# Access Compliance Report

## Public Rights-of-Way (Curb Ramps)

Intersection ID: 44950	Main Street: WEAVERS_GLENN_PL	Cross Street: OLDCORN_LN	Location:	N
ADA ID: EF28A9FA8E89	Ramp Type: Perp	Initial Pass/Fail: Fail	Overall Compliance: No	Severity Score: 13.75

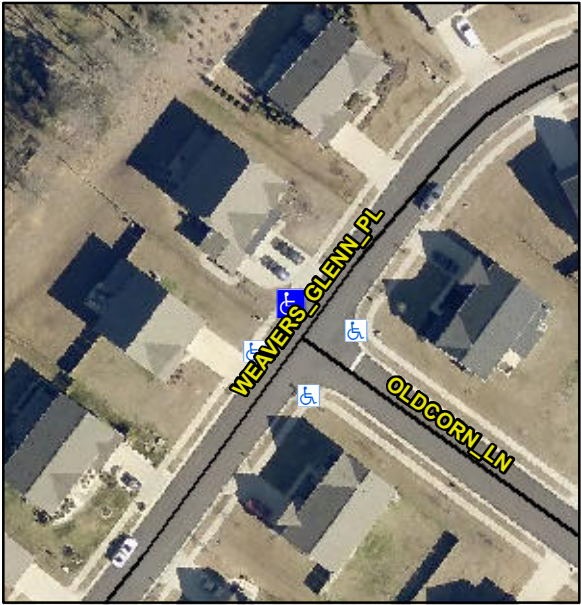
Codes/Mitigation Info/Possible Solution			Field Measurements/Component Compliance		
	Possible Solutions:		<b>Compliance</b>	<b>Description</b>	<b>Data</b>
	<b>Remove &amp; Replace Entire Ramp.</b>		<b>No</b>	Ramp Slope (%)	<b>9.6</b>
			<b>Yes</b>	Ramp Width (in)	<b>2.2</b>
			<b>N/A</b>	Flare Type LT	<b>N/A</b>
			<b>N/A</b>	Flare Slope LT (%)	<b>N/A</b>
			<b>N/A</b>	Flare Traversable LT?	<b>N/A</b>
			<b>N/A</b>	Landing Length (in)	<b>N/A</b>
			<b>N/A</b>	Landing Width (in)	<b>N/A</b>
			<b>N/A</b>	Landing Slope (%)	<b>N/A</b>
			<b>N/A</b>	Landing X Slope (%)	<b>N/A</b>
<p>Surveyor Notes:</p> <p><b>N/A</b></p> <p>PROW/ADA:</p> <p><b>Not Found, R304.2.2</b></p>			<b>N/A</b>	Flare Type RT	<b>N/A</b>
			<b>N/A</b>	Flare Slope RT (%)	<b>N/A</b>
			<b>N/A</b>	Flare Traversable RT?	<b>N/A</b>
			<b>N/A</b>	DWS Provided?	<b>N/A</b>
			<b>N/A</b>	DWS Contrast?	<b>N/A</b>
			<b>N/A</b>	DWS Length (in)	<b>N/A</b>

<b>N/A</b>	DWS Full Width?	<b>N/A</b>
			<b>N/A</b>	DWS Offset (in)	<b>N/A</b>
			<b>N/A</b>	Gutter Ponding?	<b>N/A</b>
			<b>N/A</b>	Gutter Lip Ht (in)	<b>N/A</b>
<p>Total Cost:</p> <p><b>\$ 1850.00</b></p>			<b>No</b>	Painted X Walk2?	<b>N/A</b>
			<b>To SE</b>	X Walk 2 Direction	<b>N/A</b>
			<b>N/A</b>	X Walk 2 Width (in)	<b>N/A</b>
			<b>3.9</b>	X Walk 2 Slope (%)	<b>N/A</b>
			<b>2.4</b>	X Walk 2 X Slope (%)	<b>N/A</b>
			<b>N/A</b>	Ramp inside XWalk2?	<b>N/A</b>
			<b>N/A</b>	Clear Space?	<b>N/A</b>
			<b>N/A</b>	Clear Space to XWalk (in)	<b>N/A</b>
			<b>N/A</b>	Storm Grate/Utility Hazard?	<b>N/A</b>
			<b>N/A</b>	Storm Grate/Utility Type	<b>N/A</b>
			<b>N/A</b>	Surface Condition? (G/P)	<b>Good</b>
